APPLICATION FOR CERTIFICATION FOR THE  
**IMPERIAL VALLEY SOLAR PROJECT**

**DOCKET No. 08-AFC-5**

## **ERRATA TO THE PRESIDING MEMBER’S PROPOSED DECISION**

After reviewing the comments submitted by the parties and members of the public, we incorporate the following changes to the August 26, 2010 Presiding Member’s Proposed Decision (PMPD):

**46. Page 2, second paragraph:**

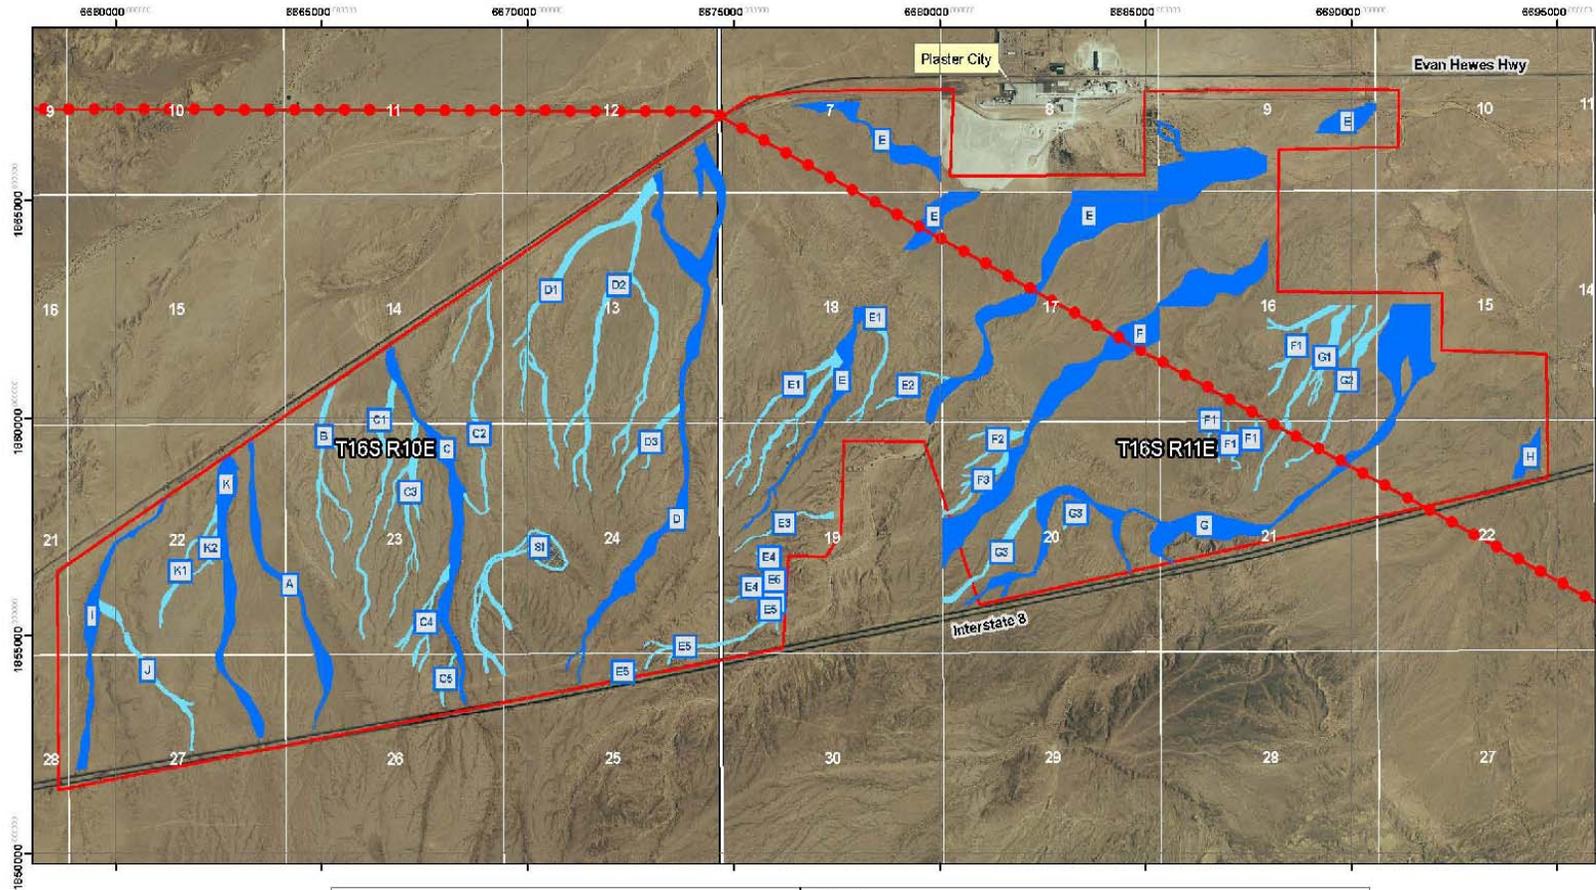
~~The SunCatcher foundations would be metal pipe pedestals 24 inches in diameter secured in place using metal fins for stabilization and driven hydraulically into the ground. The 30,000 SunCatchers would be installed in straight, parallel rows. Each row would consist of a series of SunCatchers in pairs, one on each side of a central access road. The distance between paired dishes along a row would be 112 feet. The distance between successive pairs in a row would be approximately 55 feet. Thus, a row 1,000 feet long would have approximately 38 SunCatchers. A 12-foot-wide unpaved access road would run along the centerline of each row, with a 15-foot unpaved maintenance road extending 60 feet to each side of the maintenance road at each SunCatcher pair. A row 1000 feet long would be serviced by approximately 28,200 square feet of unpaved roadway. The distance between rows would be 72 feet.~~
